1.1 This note has been prepared by DTA Transportation in response to further comments by the Local Highway Authority (LHA). An application was submitted (Ref: 24/0278) for the demolition of the existing petrol filling station and car wash, and construction of a replacement petrol filling station, including new kiosk building. The comments from the LHA are included at **Appendix A**.

Ref: RECON 24/0278

SITE: 71 Cardiff Road Newport NP20 2EN

ST/SC 26234-03c DSP
7th July 2025

26234-05b Swept-Path Assessment

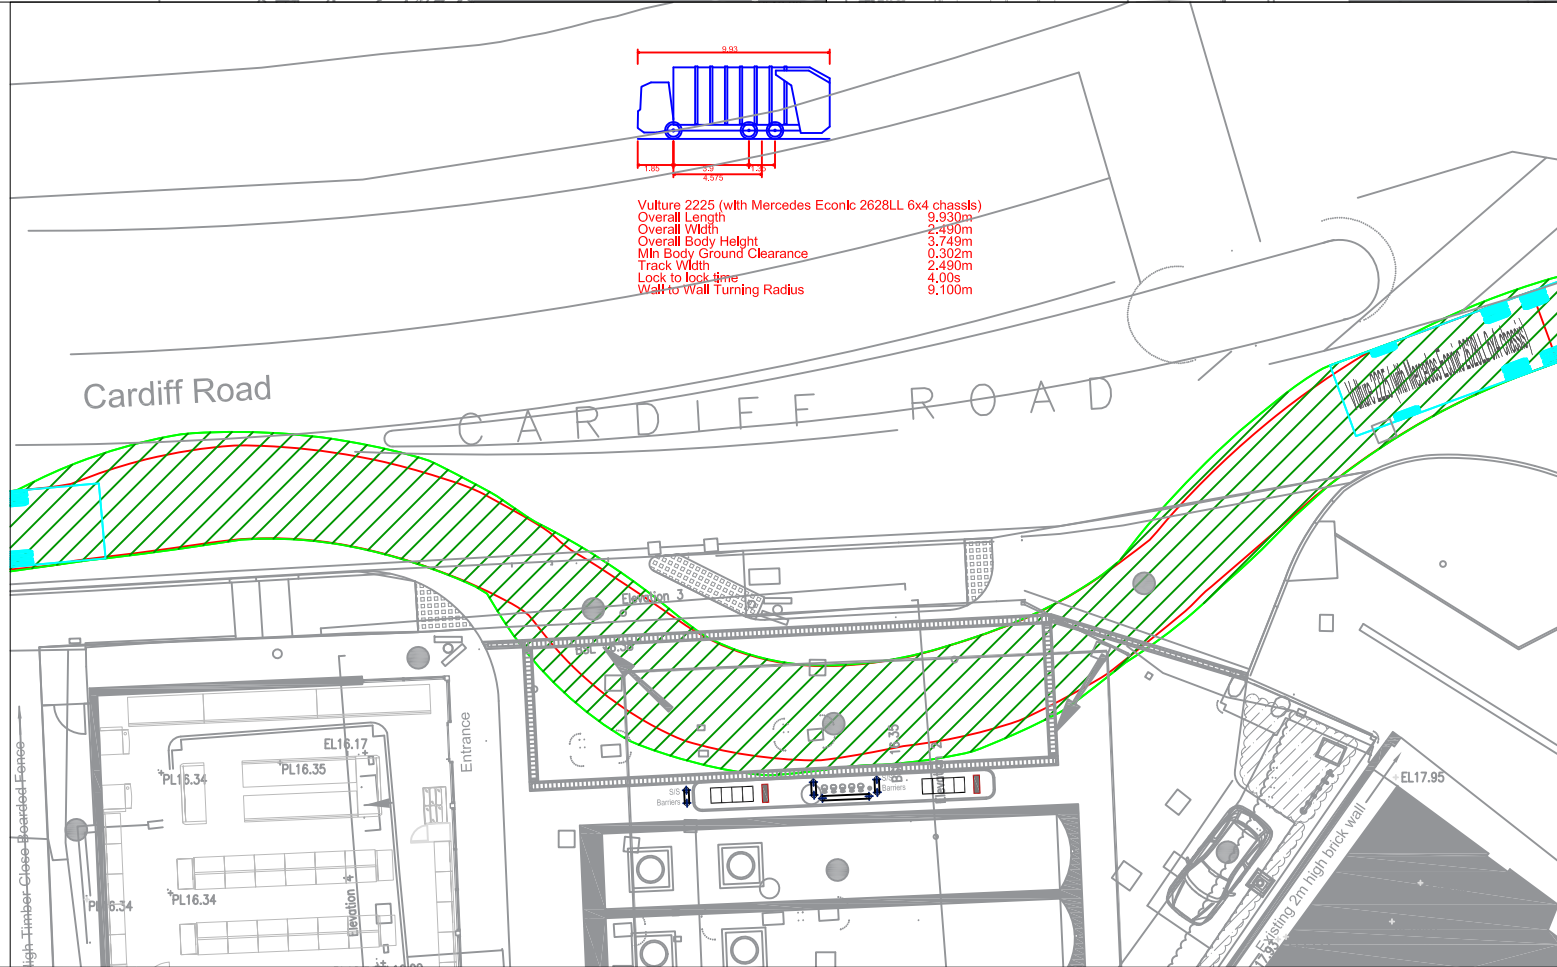
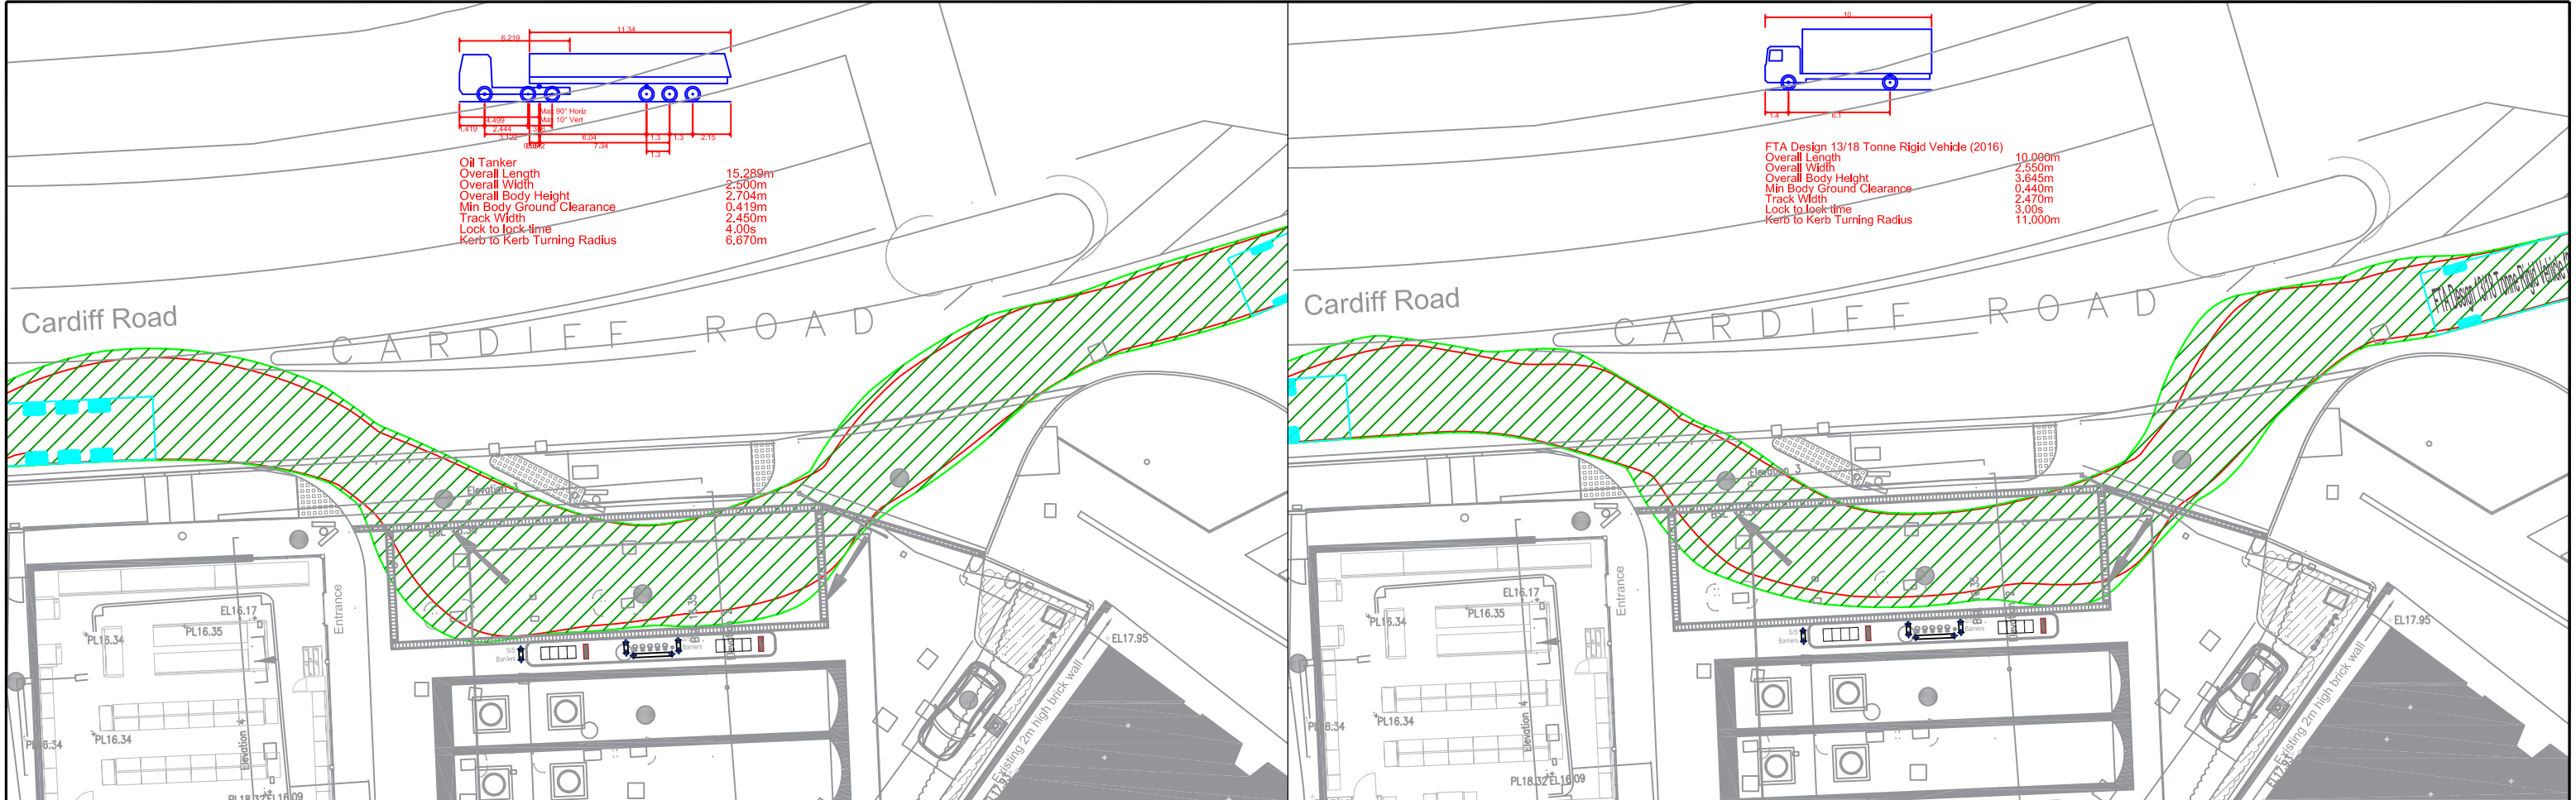
The amended servicing plan suggests that all vehicles except the tanker can be accommodated within parking areas, which would be acceptable, but the swept path assessment do not show this. If they are to park at the front, they raise the same issues as the tanker and would have to have the same conditions in terms of hours and banksman.

In addition, we would raise concerns regarding the highway approach angle for tankers exiting the site. HGV already have difficulty with limited visibility (even ahead). We cannot support these leaving at an acute angle for reasons of highway safety, particularly pedestrian safety.

The fuel deliveries will occur at night-time when there are fewer pedestrian movements. However, the DSP has been amended to include reference to a marshall/ banksman assisting when the oil tanker leaves the site.

3.2.2 A swept-path assessment has been undertaken of the site access/egress and internal arrangements for an oil tanker, as the largest anticipated service vehicle, a 10m rigid for retail deliveries, a 10m long refuse vehicle, typically used by a private commercial waste collector. The swept path analysis is shown on **DTA Drawing 26234-05b** within the DSP.

- All service and delivery vehicles associated with the operations are able to access and egress in forward gear;
- The rigid vehicle and refuse vehicle can be accommodated in the proposed parking area without compromise to other vehicles movements.
